# Inter-sublayer service interface for training

(comments #194, #195 against D1.0)

Adee Ran, Cisco

# Information flow between PMA interfaces

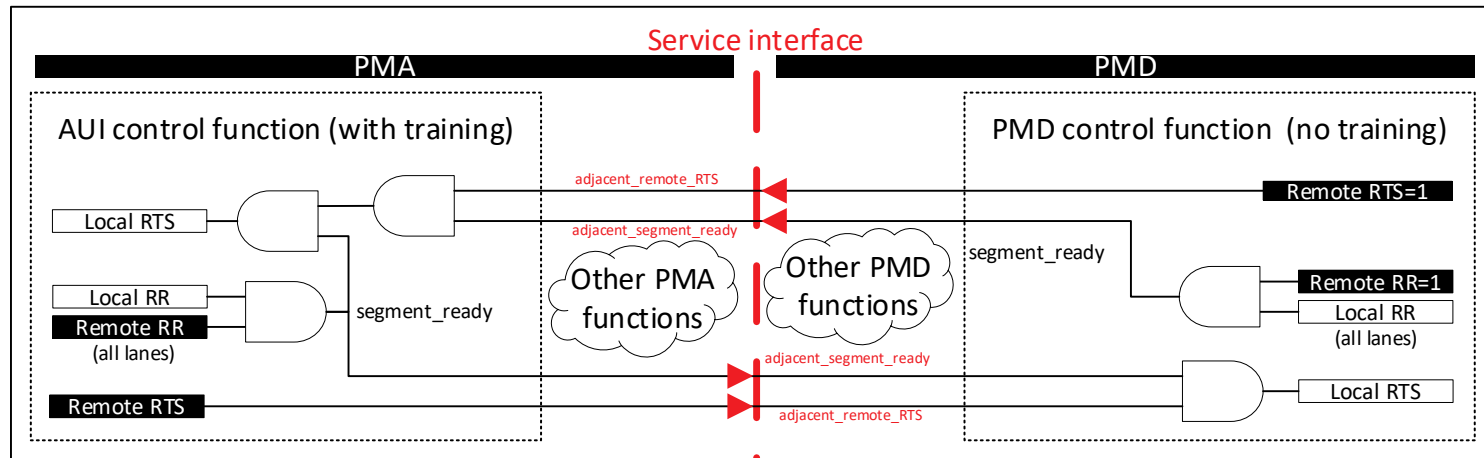
The diagram presented in the training proposal assumed that the training is a function of the PMA (assuming the PMA includes the SerDes), and thus the signals shown by the arrows are internal variables.

However, in implementation of the training proposal in D1.0 it was decided that the training belongs in the PMD or the AUI transceiver.

**Thus, the training information that was supposed to be internal to the PMA needs to be passed between sublayers over the inter-sublayer service interface...**

# Information flow across service interfaces

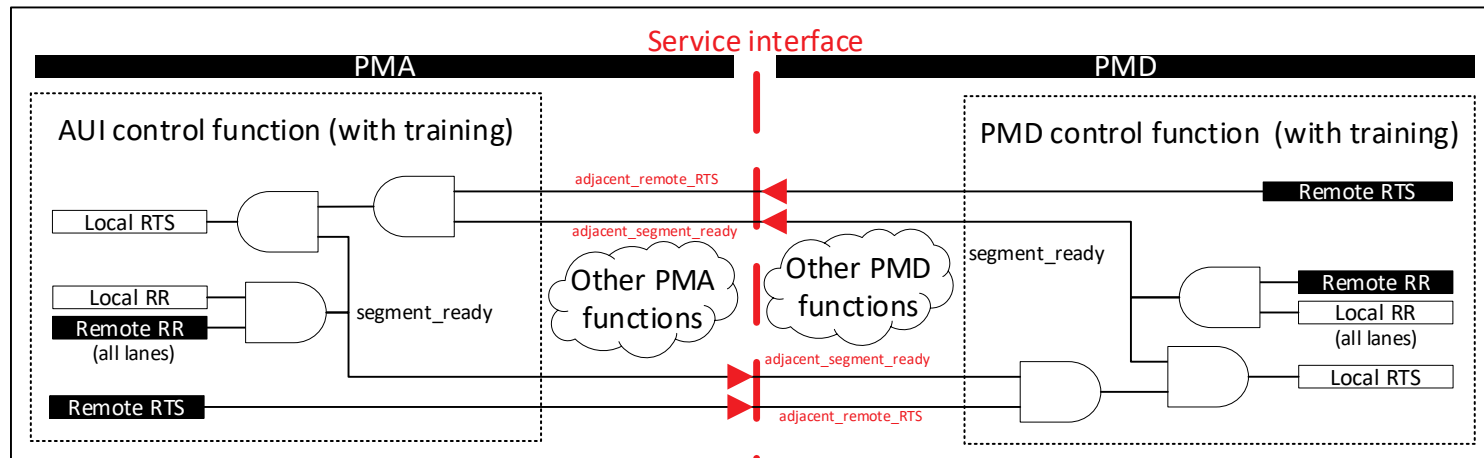
Two bits of information are passed between sublayers in each direction:

- `segment_ready` – essentially “segment-level signal detect”
- `remote_RTS` – essentially “link-level signal detect”

In addition, indication of training failure should be communicated.

Can this be done with the existing service interface?

Figure 73–11—Arbitration state diagram

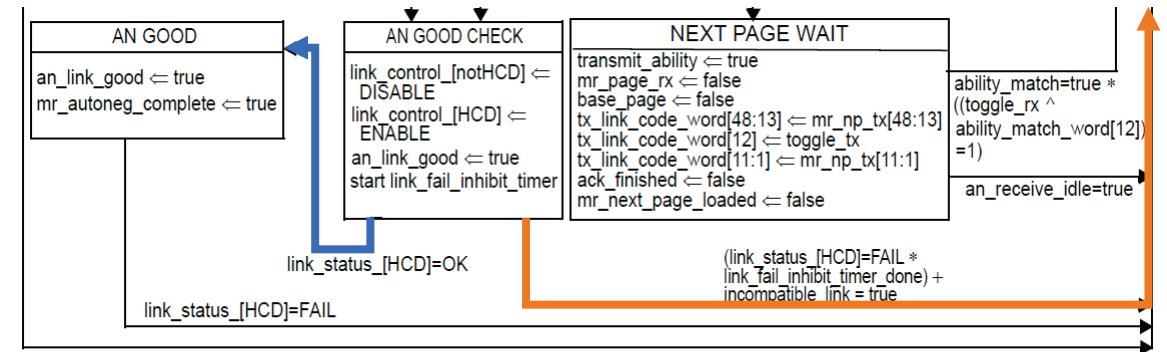
- Once AN selected a PHY (HCD) and enabled it, if **link\_status** is **FAIL** for long enough time (**link\_fail\_inhibit\_timer**), then **AN will time out, disable the PHY, and restart...**

- But configuration and training on multiple segments can take an arbitrarily long time!
  - Having a long timeout has implications on recovery time
- Currently, the only way to prevent this restart is that the AN **receives link\_status=OK from the PCS before the timer expires.**

- It is preferable not to have a mandatory timeout/restart when training is running on any of the AUIs.
  - Management can always restart AN or training, but this should be done only when a failure is indicated.

- As an alternative we could specify that PMD training starts only after AUIs have completed training.
  - While AUI are trained, AN signaling (e.g. null pages) should be continued on the media.
  - This would prevent `link_fail_inhibit_timer` from starting...
  - But also prevent concurrent training of multiple segments

It is preferable to allow concurrent training when possible. This method should be considered as a last resort.

- A possible way is to define a third possible value for link\_status, **IN\_PROGRESS** (in addition to “FAIL” and “OK”).
- link\_status=IN\_PROGRESS when any PMA inside the PHY is sending training frames (which can happen for an arbitrarily long time).

- This is indicated by having either IN\_PROGRESS or READY in the PMA:IS\_SIGNAL.indication.
  - link\_status=IN\_PROGRESS will keep the state diagram above in “AN GOOD CHECK” state, preventing AN from restarting.
